**WEST VIRGINIA DEPARTMENT OF ENVIRONMENTAL PROTECTION
WV/NPDES CONSTRUCTION STORMWATER PERMIT**

FACILITY NAME:	Northport Avenue Extension			REG. #	EXPIRE DATE:
PERMITTEE	RANSON, CITY OF			WVR110191	9/11/2020
ADDRESS/PHONE:	Attn: ANDREW P. BLAKE, CITY MGR 312 SO MILDRED ST RANSON, WV 25438 3047251010				
LOCATION:	39 22 12.95 N, 77 52 32.83 W			Entry Date/Time:	3/11/2020 @ 1136
COUNTY:	Jefferson			Exit Date/Time:	3/11/2020 @ 1243
Site Representative /Phone				PHOTOS <input checked="" type="checkbox"/>	
CO-PERMITTEE:				ADDRESS:	
SITE OPERATOR:				ADDRESS:	
PERMITTED ACREAGE	24.4	WEATHER:	Overcast	LAST INSPECTION:	2/06/2020
RECEIVING STREAM(S)	Rockymarsh				NOV: 0
Regular Mail <input checked="" type="checkbox"/>	Certified Mail <input type="checkbox"/>	Tracking #			
OVERALL FACILITY RATING:	Marginal		COMPLIANCE OUTCOME	Immediately Corrected

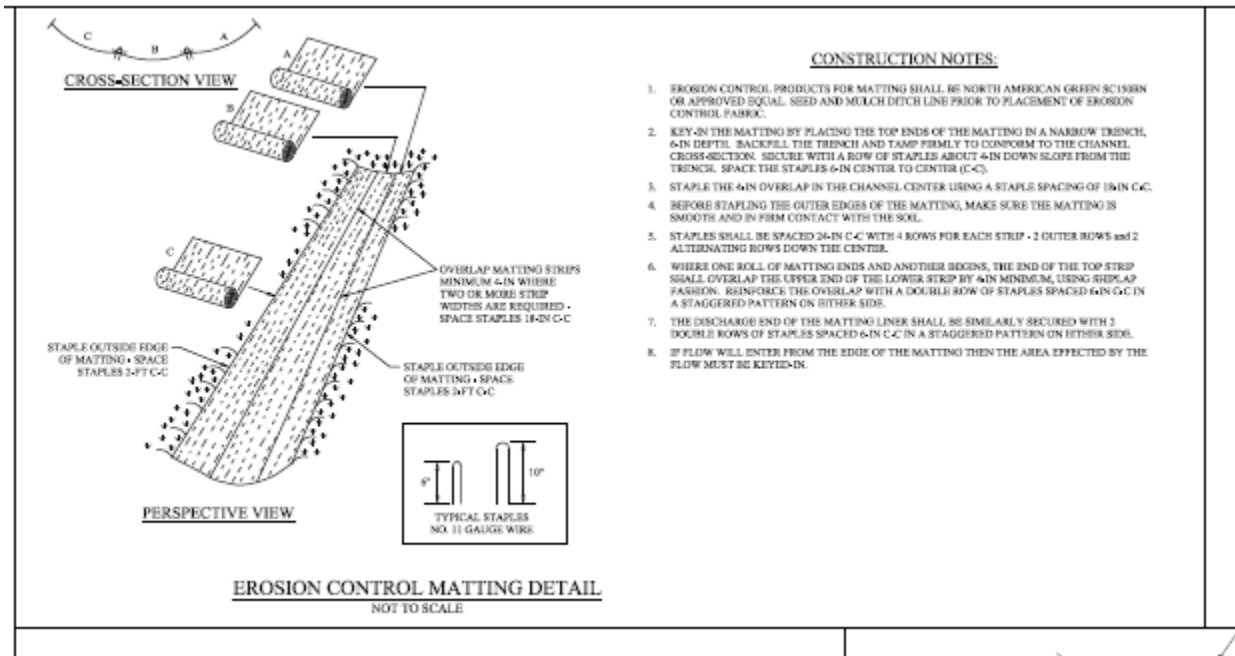
Drop inlet with out protection on side after maintenance was performed. Was immediately corrected upon notification.

Outlet marker was not place at outfall of basin 1 yet. They are being made and will be posted within the next 24 hrs.

Questioned Curlex being use as tuff reinforcement matting in concerted flow area of basin 1. Refer to Sheet 19 for erosion controls matting detail.
